**PACIFIC GAS AND ELECTRIC COMPANY  
SUPPLEMENTAL FILING ADDRESSING  
REMEDIAL COMPLIANCE PLAN AND  
FIRST QUARTERLY REPORT ACTION ITEMS**

**FEBRUARY 26, 2021**

PACIFIC GAS AND ELECTRIC COMPANY  
2021 WILDFIRE MITIGATION PLAN REPORT – SUPPLEMENTAL FILING  
FEBRUARY 26, 2021

**FIGURE 1: SYSTEM HARDENING IMPACT ON LARGE FIRE POTENTIAL**

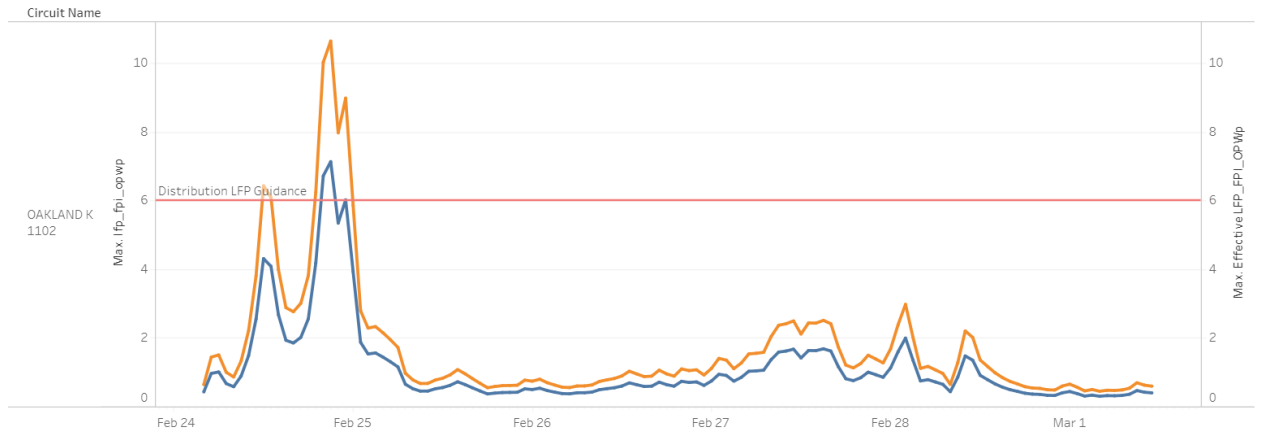
- 1) *Provide an update and explanation as to how its hardening initiatives have directly impacted its threshold values for initiating de-energization events, giving a) particular locations & b) quantitative data showing such changes.*
